S E R V I C E N O T E

70621A Preamplifier

Eliminate residual responses caused by a noisy power supply

Figure 1. A2 Power Supply/Controller Board

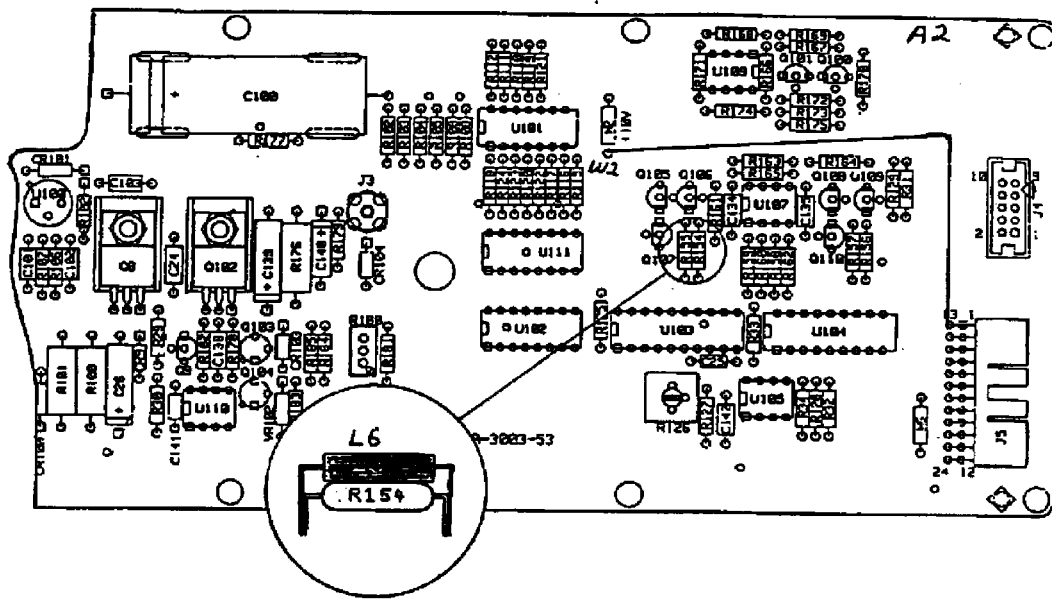
Residual responses are occurring in the 1.5 to 3.5 MHz range in systems using the 70620B Option 001 or the 70621A Preamplifiers. The responses are caused by digital signals that are present on the A2 Power Supply/Controller Board which are conducted onto the +5V supply and also onto A4 Hi/Lo Band switch control line. The +5V supply is shared by the A7 RF amplifier microcircuit which is highly sensitive to a contaminated supply.

The biasing for the RF amplifier is changed from the +5V to a +6V supply which is isolated from the digital signals. An inductor is also added in series with the switch control line to work with the feedthru capacitor in the switch to create a low pass filter. R154 is in parallel with L6 to limit the Q of the filter to 2.

1. Jumper A2W2 with 26 ga. wire to A2J5 pin 13. See Fig 1.
2. Secure the wire to the A2 board with Hardman Adhesive.
3. Remove the original A2R154 and replace it with a 121 ohm resistor.
4. Load A2L6 "piggy back" onto A2R154 and solder into place. See Fig 1.
5. Remove original W5 wiring harness assembly and replace with the 70620-60116 for the 70620B or 70621-60007 for the 70621A.
